The Commission has issued the enclosed Amendment No. 80 to Facility Operating License No. DPR-62 for the Brunswick Steam Electric Plant, Unit 2. The amendment consists of changes to the Technical Specifications in response to your application of July 21, 1982 as supplemented by letter dated April 28, 1983.

Amendment No.80  
License No. DPR-62

ATTACHMENT TO LICENSE AMENDMENT N° 80

SUPPORTING AMENDMENT NO. 80 TO FACILITY LICENSE NO. DPR-62

FIGURE 3.2.1-4

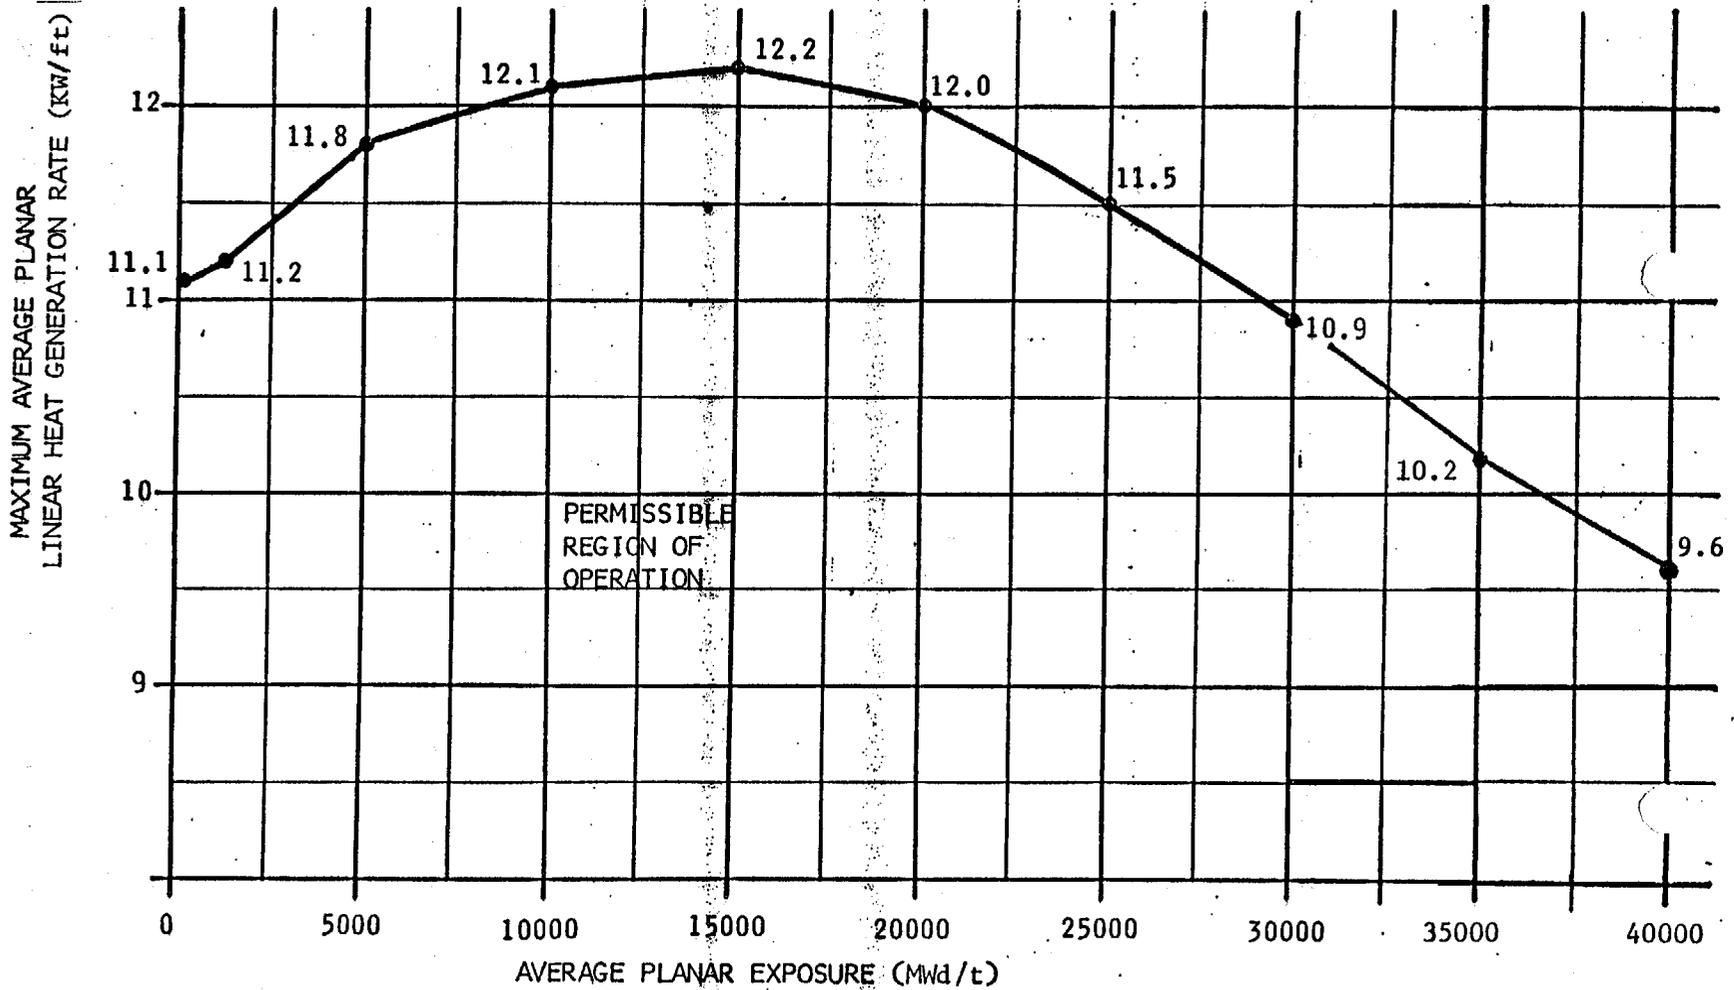
The amendment changes the Technical Specifications with regard to limiting values of the Maximum Average Planar Linear Heat Generation Rate (MAPLHGR). The amendment abrogates a uniform reduction of 8.5 percent in the limiting values of the MAPLHGR and is based on the restoration of a cracked core spray sparger to its fully operational state.

The amendment revises the Technical Specifications to remove a uniform reduction of 8.5 percent in the limiting values of the Maximum Average Planar Linear Heat Generation Rate.
